# MEMORANDUM

To: El Paso County PCD File #: PPR-2315

Re: Super Star Car Wash (Claremont Business Park 2) Traffic Compliance Letter

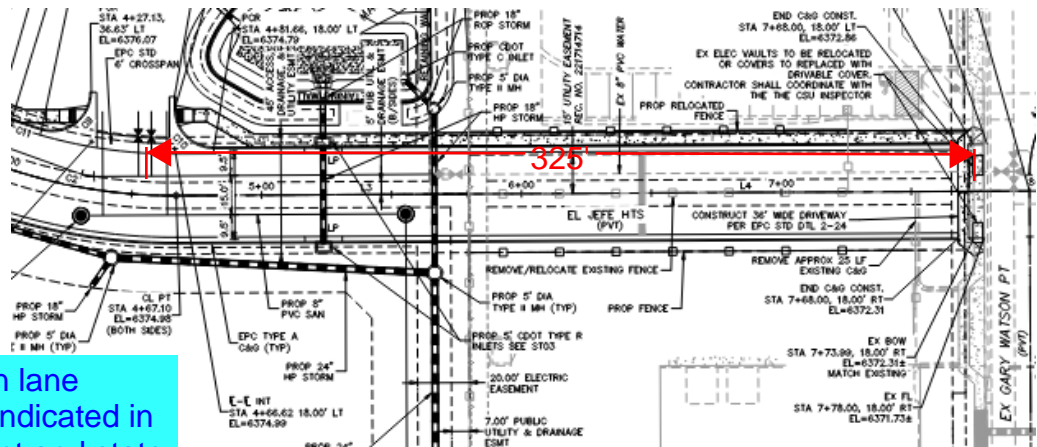
please state whether this sight distance is met. It appears there is approx. 325' to the intersection of el jefe heights and Gary Watson Point.

Please provide Aux. turn lane analysis for this site as indicated in previous review comment and state whether a turn lane from El Jefe Heights into the driveway is needed/recommended.

Text was added to note whether required sight distance can be met.

Discussion of Aux Turn Lane analysis was added
